Review of “Analysis of Lightning-Induced Currents in Supply Cable Shields and Their Impact on LLS Sensor Site Errors “ by Kohlmann et al., initial draft Reviewer: Martin Murphy

Figure 1: $Z_1 = 0 \Omega$ (short circuit) and $Z_2 = 1e6 \Omega$ (open end), $\sigma_g = 10^{-5} S/m$, $d = 10$ cm, $\epsilon_{rd} = 3$, $\epsilon_{rg} = 10$.

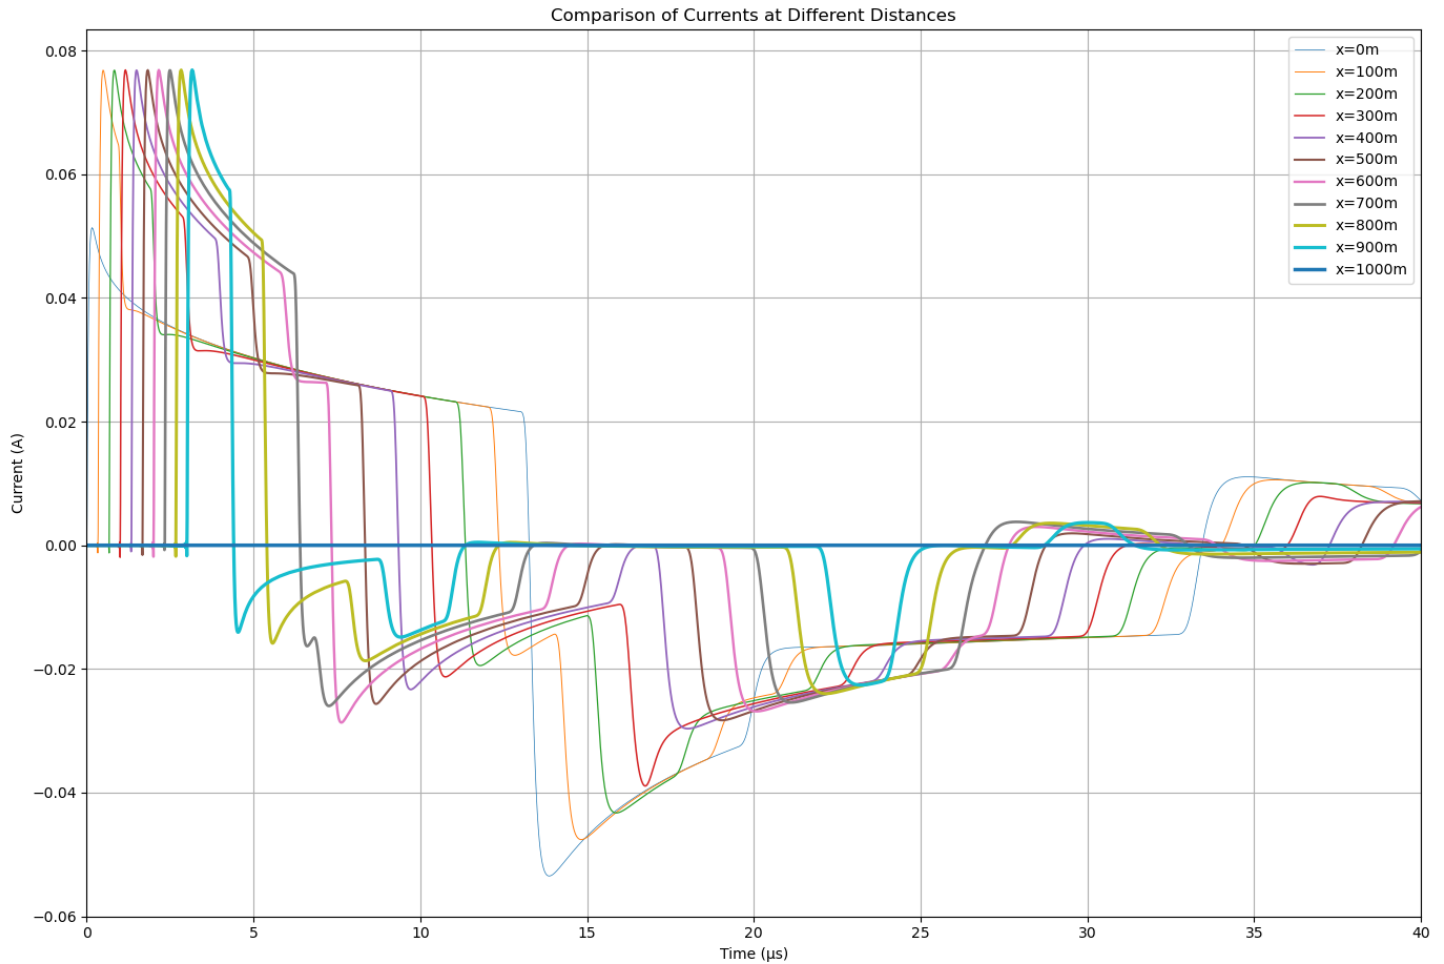
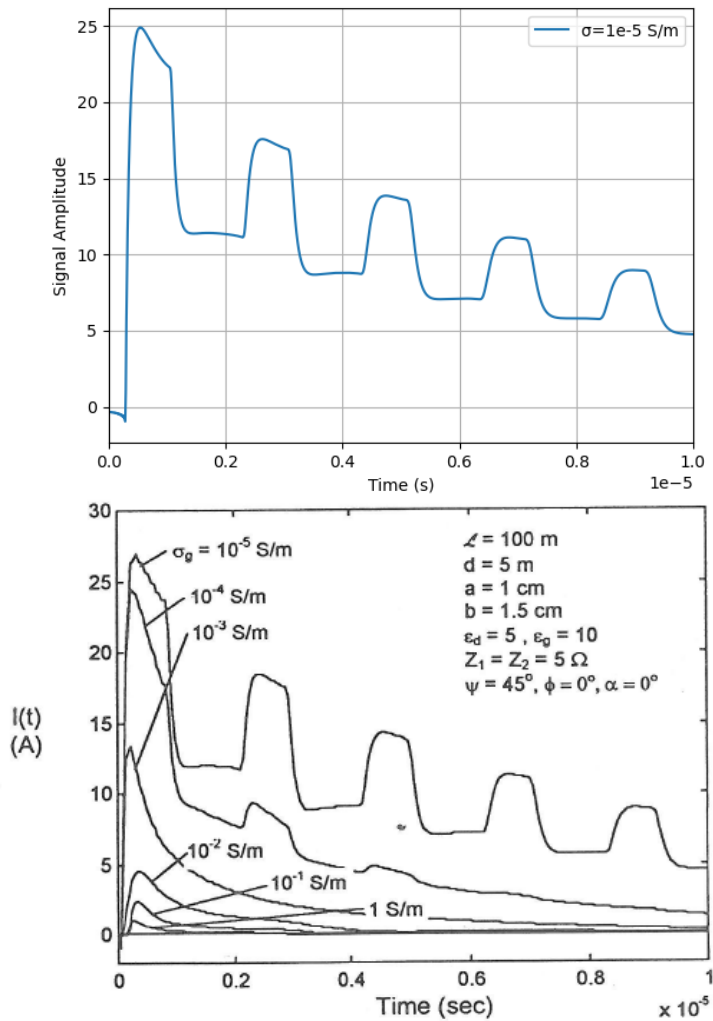
6. I am confused about Fig. 11, although I may have figured out some of the issues. In both panels in Fig. 11, the legends say “L = nnn”, but I think that it should be “x = nnn”. If these are really positions along the line, then it should be stated in the caption or the body of the manuscript. Also, the text states that the peak current at the line end in Fig. 11(a) is 82 mA, but it looks like 100 mA. For both Fig. 11 a & b, I am unable to reconcile the 15-20 microsecond periodicity in the current waveforms. Why does this periodicity exist for the cable grounded at both ends (11a)? This period also seems quite long, given that the round-trip time to one end and back, at the speed of light, is about 3 microseconds. A discussion of this would be helpful.

Thank you for the important input and the questions – the legend naming was indeed confusing and should read x=... which was corrected in the revised version, and the figure caption was adapted to “Shield currents of an insulated cable of 450 m length at various locations x responding to a distant (100 km) lightning-incident field, as shown in Fig. 7 for $\sigma_p = 10 \cdot 10^{-3}$ S/m, $\sigma_{loc} = 10 \cdot 10^{-3}$ S/m. Burial depth $d = 1$ m.”. The peak current value of 82 mA at the line end was a remnant of a previous graph generated with a different set of parameters and was not updated to match the new graphs. Thank you for catching this! Regarding the second question, how the significant changes in the current waveform and the periodicities, it is important to highlight that the propagation speed is not the speed of light but rather the velocity of an EM field propagating in the ground with a relative permittivity of $\epsilon_{rg}=10$, i.e.,

approximately $c_0/\sqrt{10}$ which is about one third of the speed of light. This velocity is further reduced by the dielectric properties of the insulation (cable jacket), with higher relative permittivity causing greater reduction. As reported by Bridges, 1992, the wave vector k , and thus the velocity, is further perturbed by losses, i.e., with changing electric ground conductivity σ_g . When interpreting the propagating fields, two factors must be considered: (1) This effective propagation velocity, and (2), depending on the line length, the frequency content of the impinging field (sharp versus smooth transient fields). Under certain conditions, the superposition of forward- and backward-travelling wave components may become difficult to distinguish in the resulting waveform, in particular when attenuation due to losses cause significant dispersion.

We can demonstrate this in this document by presenting a plot for a very sharp transient (with sub-microsecond risetime) illuminating a cable that is located close to the surface (10 cm below ground), in a very low conductivity soil ($\sigma_g = 10^{-5} S/m$). In this case, current dispersion during propagation is minimal (see Figure 1). Further, to highlight reflection phenomena, the line length is chosen to be $L = 1000$ m, terminated by $Z_1 = 0 \Omega$ (short circuit) and $Z_2 = 1e6 \Omega$ (open circuit). The current profile is sampled every 100 m. Under these conditions, the effects of the two traveling waves (forward and backward) and their reflections can be clearly distinguished in the current waveforms at different distances. For the simulation results shown in Fig. 11, such distinction is no longer possible due to the longer risetime, the chosen ground and line parameters, and the resulting dispersion/attenuation. Nevertheless, some reflection effects of the main travelling wave(s) are still visible in Fig. 11, for example, at about $10 \mu s$ at $x=450$ m, where the current drops from 90 mA to 40 mA.
